## QUESTIONS AND STATEMENTS FROM THE PUBLIC TO THE PLANNING COMMITTEE ON 8 FEBRUARY 2022

Application No : 19/02109/S73/1 Section 73

268 Springfield Road Chelmsford CM2 6AS

Variation of condition 2 to approved permission 19/02109/S73 - (Demolition of existing garage. Proposed replacement dwelling, with detached pool house and tennis court - Demolition of existing cart lodge. Construction of single storey extension to side elevation. Alterations to fenestration. Alteration to gymnasium layout and fenestration). Alteration of the height of the gymnasium.

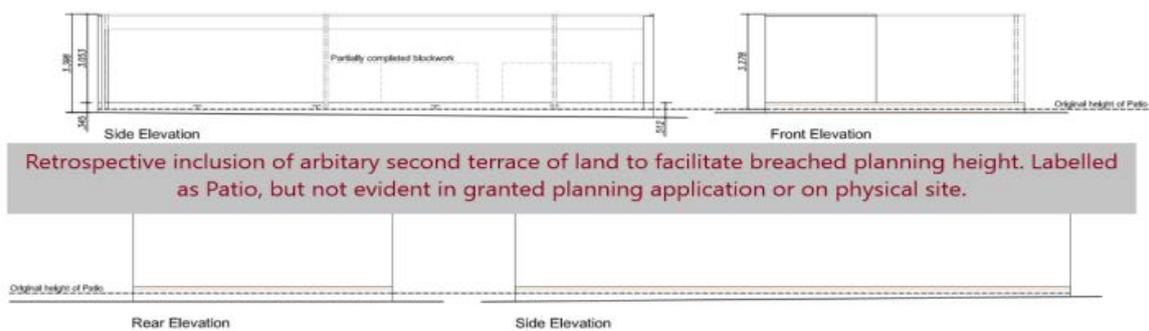
As shown below, the approved planning makes no reference to a change in ground levels for any additional patio - as only one level was in existence. Nor does the original application contain a free form land level as given in the latest submission.

It would be detrimental to construction and fail Building Regulations to reinstate 200mm of land height, above the already existing untouched land level, without breaching the damp proof course level of the outbuilding and would sit above the finished internal floor level.

Based on the statement in 6:10 the site would have had to have been excavated down by 200 mm across the entire rear garden, which would mean removing tonnes of soil across the width of the garden, whereas in fact any site visit and existing photos provides evidence that the garden level has not changed- albeit areas have increased in height where rubble has been redistributed from the demolition of the old house.

The engineering blocks usually positioned below ground level are clearly visible and been placed to commence at existing ground level, therefore pushing the building above the permitted height by the given 200mm.
